RFI #33

DRAWING TITLE			
CONTRACT	CUSTOM HOUSE SQUARE		
MODELLED BY		ISSUE DATE	11/20/2006
CONTRACT NO	S06-087	SCALE 1/75	nsk67
REVISION Date		DRAWING No

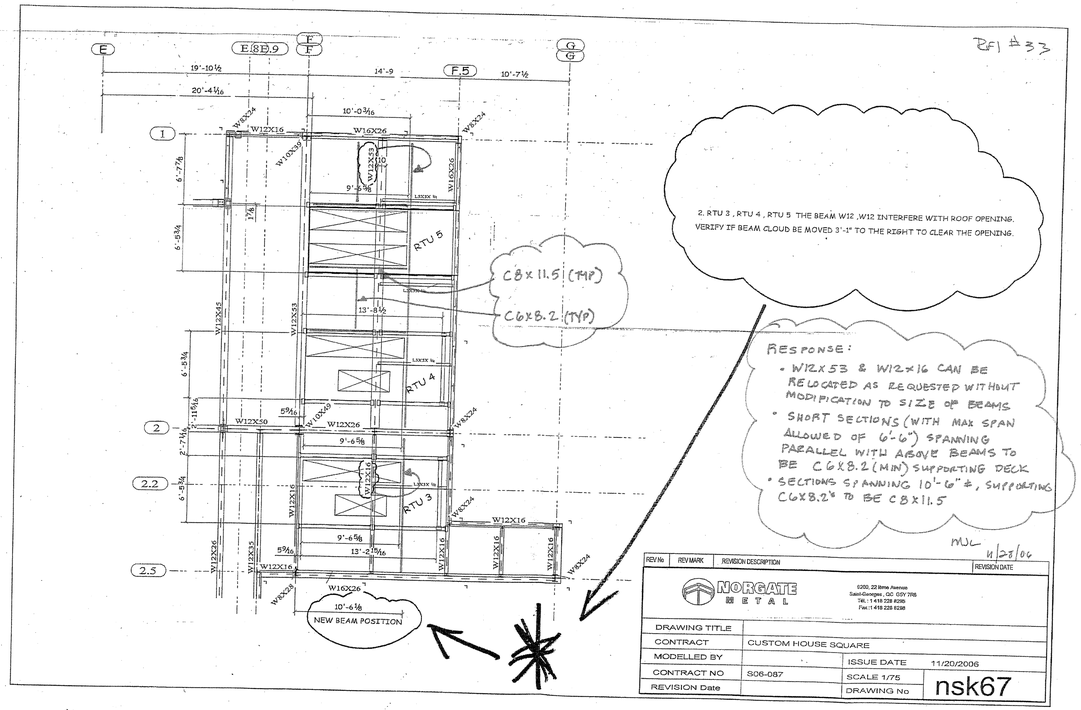
2. RTU 3 , RTU 4 , RTU 5 THE BEAM W12 ,W12 INTERFERE WITH ROOF OPENING.
VERIFY IF BEAM CLOUD BE MOVED 3'-1" TO THE RIGHT TO CLEAR THE OPENING.

- W12X53 & W12X16 CAN BE RELOCATED AS REQUESTED WITHOUT MODIFICATION TO SIZE OF BEAMS
- SHORT SECTIONS (WITH MAX SPAN ALLOWED OF 6'-6") SPANNING PARALLEL WITH ABOVE BEAMS TO BE C6X8.2 (MIN) SUPPORTING DECK
- SECTIONS SPANNING 10'-6" ±, SUPPORTING C6X8.2's TO BE C8X11.5
